**Exhibit A**

**Interpretations of Requirements R1 and R3 of Reliability Standard PRC-004-1 —**

**Analysis and Mitigation of Transmission and Generation Protection System**

**Stakeholder Comments Received During Balloting and an Explanation of How  
Comments Were Considered**

<p>Diagram 1B</p> <p>Relays protecting non-BES facility (e.g. transformer with secondary windings less than 100 kV) and tripping Breaker A are <u>not included</u> as part of BES.</p>

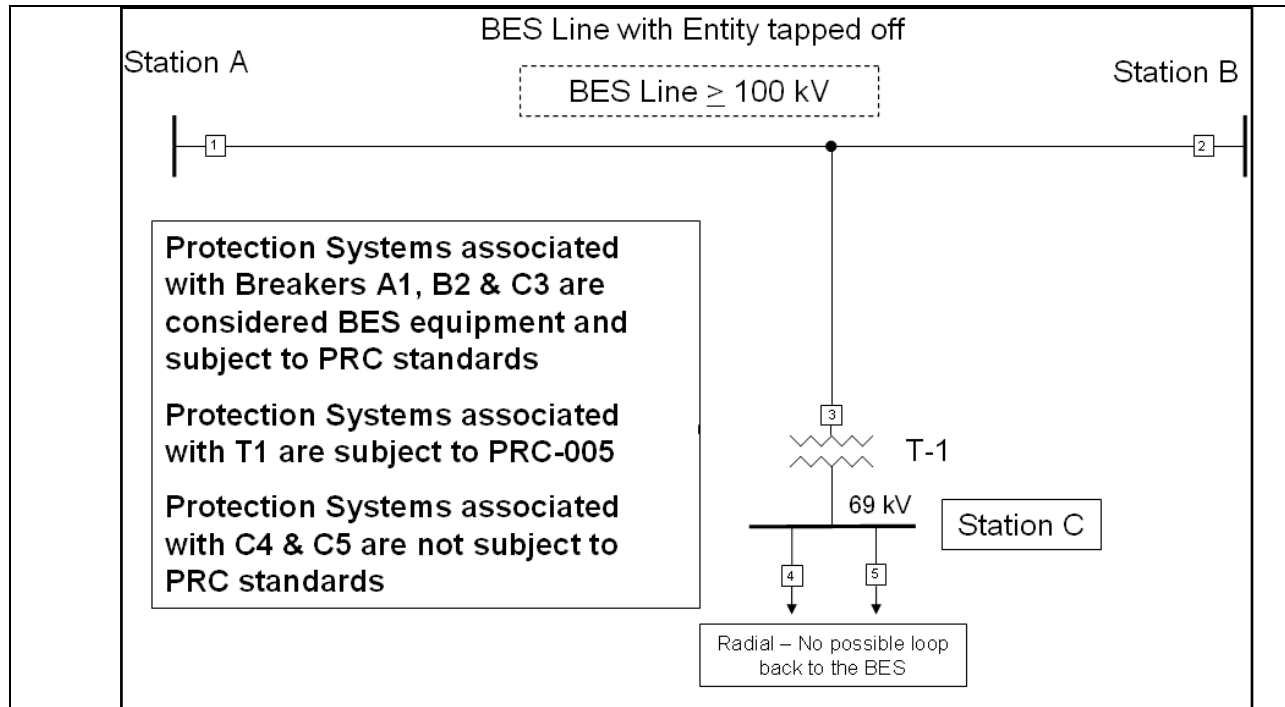
Y-W Electric Association, Inc. (Y-WEA) and Tri-State Generation and Transmission Association, Inc. (Tri-State) respectfully request an interpretation of the term "transmission Protection System" and specifically whether protection for a radially-connected transformer protection system energized from the BES is considered a transmission Protection System and is subject to these standards.

There is some debate as to what constitutes a transmission Protection System, versus any other Protection System. For example, consider a tap from a looped 115 kV transmission system where this tap consists of a step-down power transformer and its associated distribution system. The Protection System includes the transformer protection equipment (overcurrent and differential relaying with a circuit switcher) and the associated distribution system protection equipment (usually reclosers). For this example, all connected distribution facilities are designed to be radial in nature and are normally operated radially, with only the possibility of being briefly connected in parallel with other distribution facilities during switching to feed this load from another substation while this substation is taken out of service.

In this example, the looped 115 kV transmission system may be part of the Bulk Electric System and its protective relays and breakers located at the endpoints of this line section would be considered transmission Protection Systems and be subject to these standards. The status of the transformer protection equipment is unclear, though. The protective relays and the circuit switcher are connected at or attached to equipment that is connected at 115 kV, but this equipment is essentially connected to the BES radially, serves radial load, and is not necessarily designed to protect the transmission system to which it is connected. In fact, in many cases this equipment is designed strictly to protect the transformer from overloads and

There is a lack of consistent application or interpretation of these rules between various Regional Entities. For instance, ReliabilityFirst Corporation's Appendix A to their Bulk Electric System Definition shown below (available at <http://www.rfirst.org/Documents/AboutUs/Members/RFC%20BES%20Definition.pdf>) directly addresses this question, indicating that the transformer protection equipment in the above example would not be considered a transmission Protection System.

However, slide 42 of Western Electricity Coordinating Council's PowerPoint presentation from their August 12, 2008 Relay Workshop (available at <http://www.wecc.biz/documents/library/compliance/2008/2008%2008%2012%20-%20Relay%20Workshop%20-%20Portland,%20OR%20-%20Presentation.ppt>) and shown below, also directly addresses this question, indicating that the equipment in the example above would be considered a transmission Protection System and would be subject to PRC-004-1 and PRC-005-1.

Response:
<p>The request for interpretation of PRC-004-1 Requirements R1 and R3 focuses on the applicability of the term “transmission Protection System.” The NERC Glossary of Terms Used in Reliability Standards contains a definition of “Protection System” but does not contain a definition of transmission Protection System. In these two standards, use of the phrase transmission Protection System indicates that the requirements using this phrase are applicable to any Protection System that is installed for the purpose of detecting faults on transmission elements (lines, buses, transformers, etc.) identified as being included in the Bulk Electric System (BES) and trips an interrupting device that interrupts current supplied directly from the BES.</p> <p>A Protection System for a radially connected transformer energized from the BES would be considered a transmission Protection System and subject to these standards only if the protection trips an interrupting device that interrupts current supplied directly from the BES and the transformer is a BES element.</p>

<p>Diagram 1B</p> <p>Relays protecting non-BES facility (e.g. transformer with secondary windings less than 100 kV) and tripping Breaker A are <u>not included</u> as part of BES.</p>

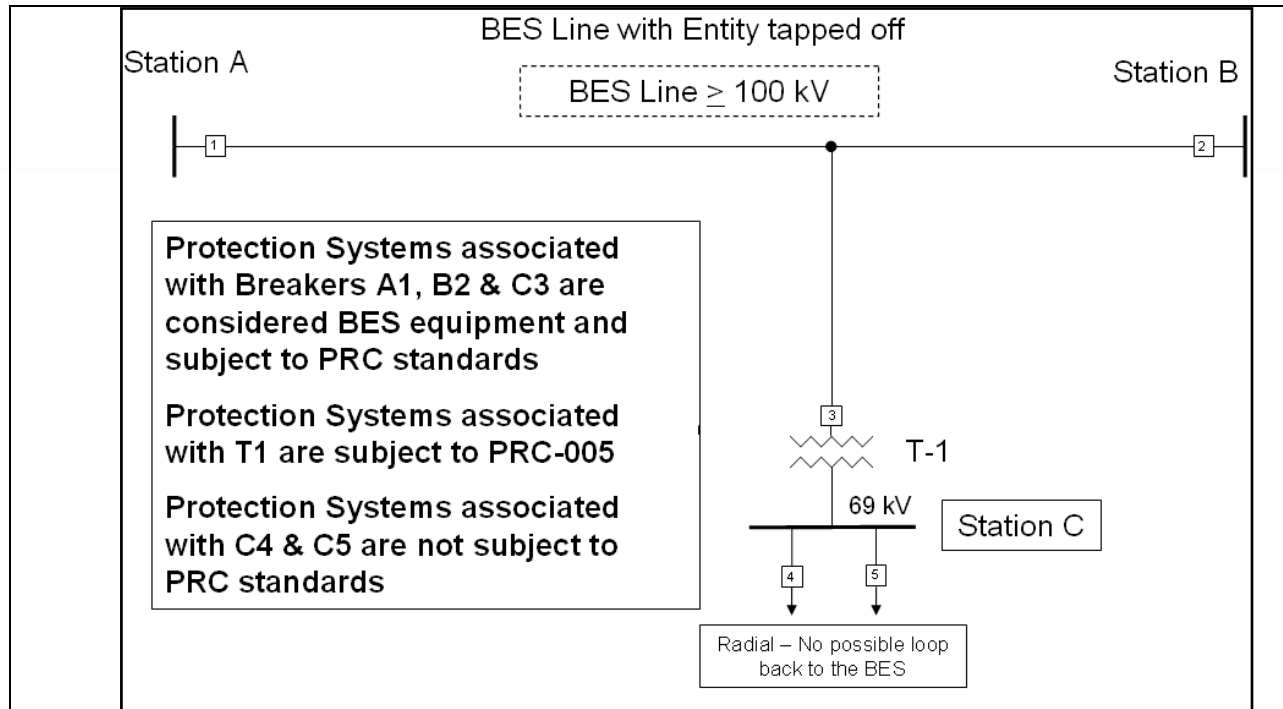
However, slide 42 of Western Electricity Coordinating Council's PowerPoint presentation from their August 12, 2008 Relay Workshop (available at <http://www.wecc.biz/documents/library/compliance/2008/2008%2008%2012%20-%20Relay%20Workshop%20-%20Portland,%20OR%20-%20Presentation.ppt>) and shown below, also directly addresses this question, indicating that the equipment in the example above would be considered a transmission Protection System and would be subject to PRC-004-1 and PRC-005-1.

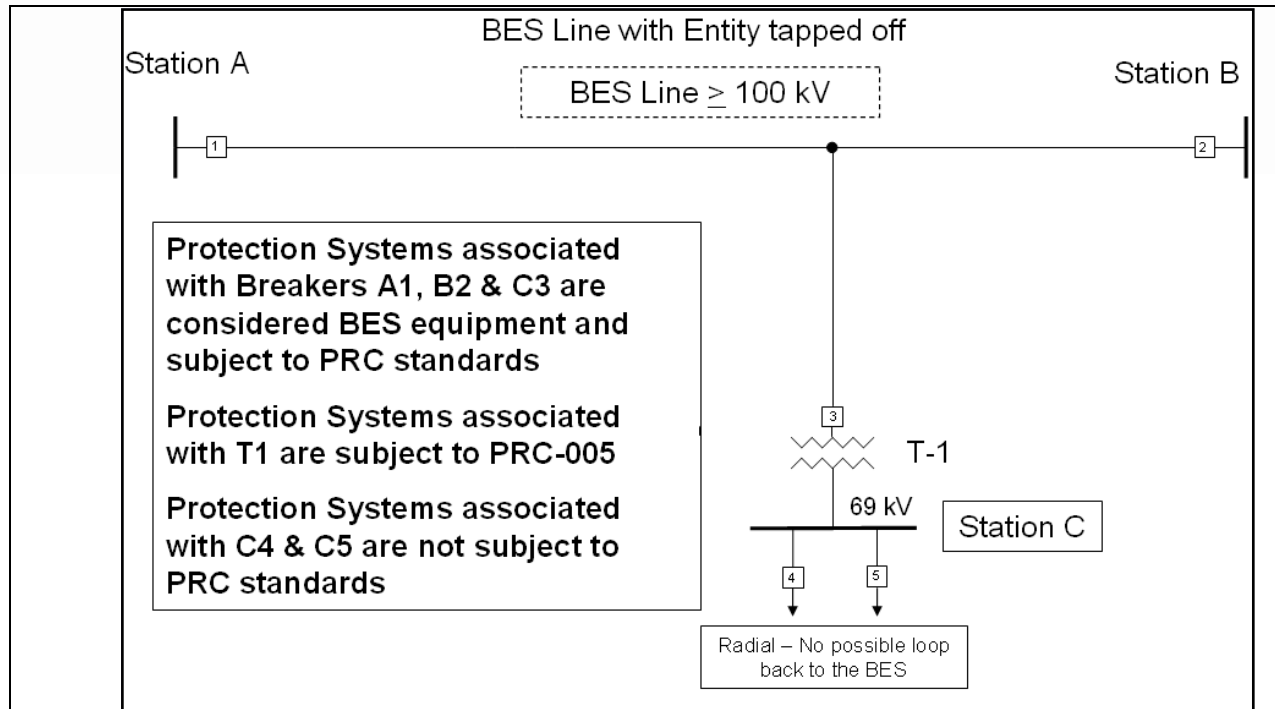
There is some debate as to what constitutes a transmission Protection System, versus any other Protection System. For example, consider a tap from a looped 115 kV transmission system where this tap consists of a step-down power transformer and its associated distribution system. The Protection System includes the transformer protection equipment (overcurrent and differential relaying with a circuit switcher) and the associated distribution system protection equipment (usually reclosers). For this example, all connected distribution facilities are designed to be radial in nature and are normally operated radially, with only the possibility of being briefly connected in parallel with other distribution facilities during switching to feed this load from another substation while this substation is taken out of service.

In this example, the looped 115 kV transmission system may be part of the Bulk Electric System and its protective relays and breakers located at the endpoints of this line section would be considered transmission Protection Systems and be subject to these standards. The status of the transformer protection equipment is unclear, though. The protective relays and the circuit switcher are connected at or attached to equipment that is connected at 115 kV, but this equipment is essentially connected to the BES radially, serves radial load, and is not necessarily designed to protect the transmission system to which it is connected. In fact, in many cases this equipment is designed strictly to protect the transformer from overloads and through-faults relating to the connected distribution system as well as to minimize

transformer damage resulting from internal faults by rapidly de-energizing the transformer for such internal faults.
